**STAFF REPORT:** 9/10/25 REGULAR MEETING

**APPLICATION NUMBER:** HDC2025-00297

**ADDRESS:** 4758 STURTEVANT

**SCOPE:** REPLACE WINDOWS, REPLACE GUTTERS/DOWNSPOUTS, REPLACE/RESTORE DOORS, HOUSE/GARAGE ROOF, REBUILD PORCH\* (WORK COMPLETED WITHOUT APPROVAL).

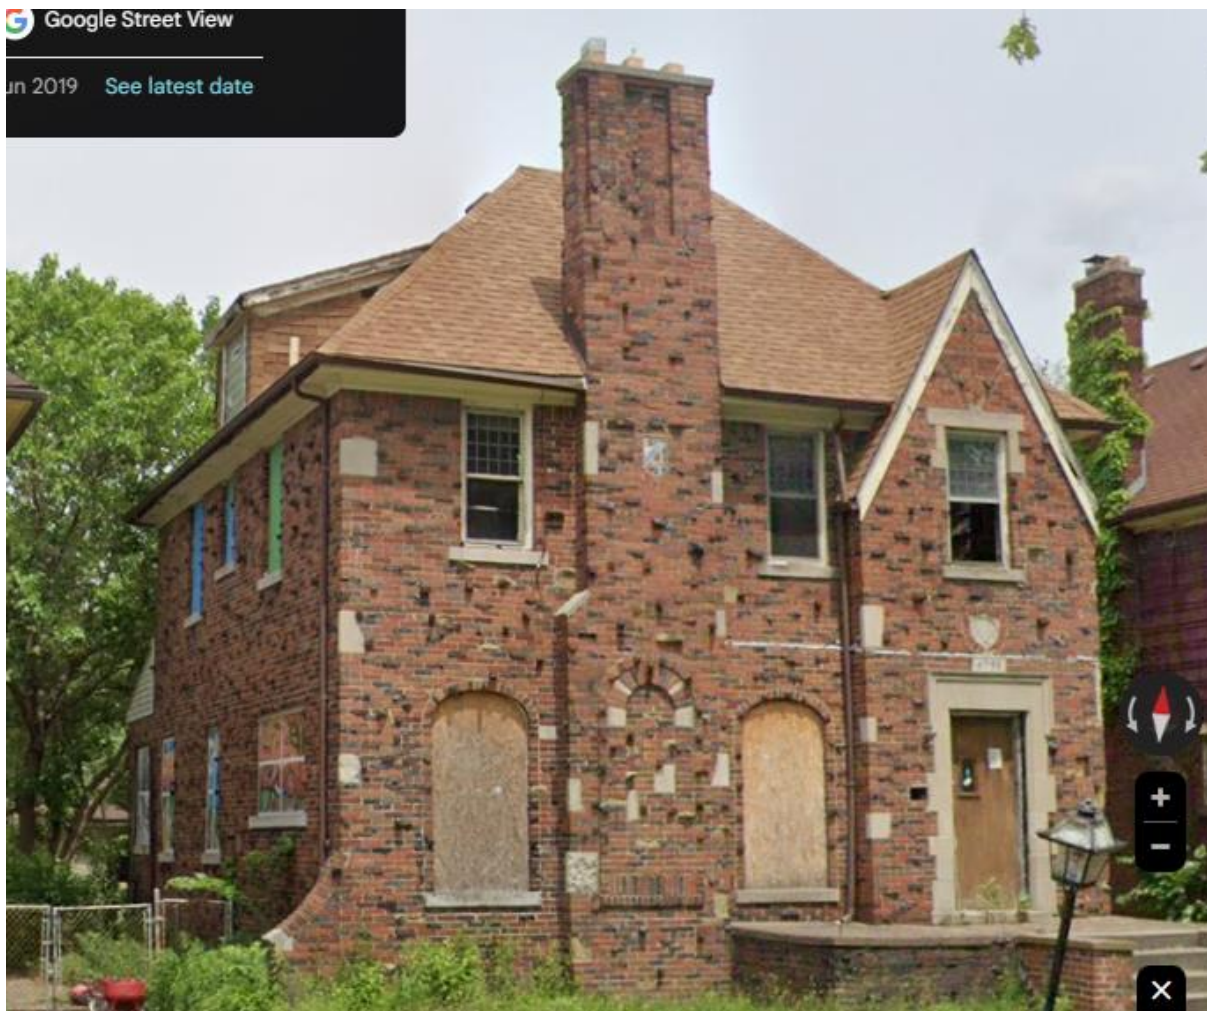
*Google streetview, August 2013. Second-floor windows are in the same position as in 2011. First-floor window is covered or boarded. Exterior storm door, second-floor decorative railing, and low porch railing are all gone. Shrub is overgrown.*

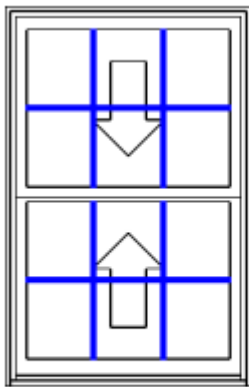
existing: on rear, a second-floor double-hung window appears to be in place; material and condition unknown. A ribbon of three windows mulled together is on rear and two of these retain their leaded glass in the upper sashes.

proposed: vinyl single-hung windows with installed grilles on top and bottom sashes to simulate muntins
